This Service Information bulletin supersedes SI B13 07 12 **dated October 2013**.

N63 and S63 Engine: High-pressure Fuel Injector Replacement Procedures

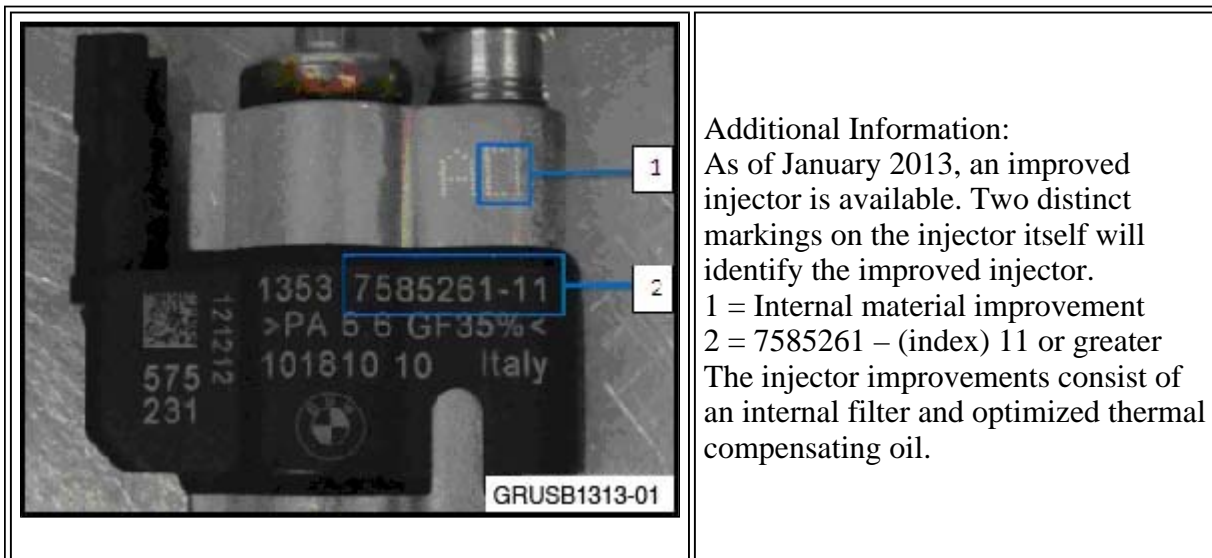
As of January 2013, an improved injector is available. Two distinct markings on the injector itself will identify the improved injector.

1 = Internal material improvement
2 = 7585261 – (index) 11 or greater

The injector improvements consist of an internal filter and optimized thermal compensating oil.

IMPORTANT: Injectors with index 11 and higher have a different calibration and construction than injectors with index 10 and lower.

Due to this difference, the injectors with index 11 and higher and injectors with index 10 and lower cannot be mixed on the same engine bank (i.e., cylinders 1-4 or 5-8).

Once a bank of injectors is at index 11 or higher, the “bank set replacement” requirement no longer applies. For index 11 injector failures, only replace the failed injector.
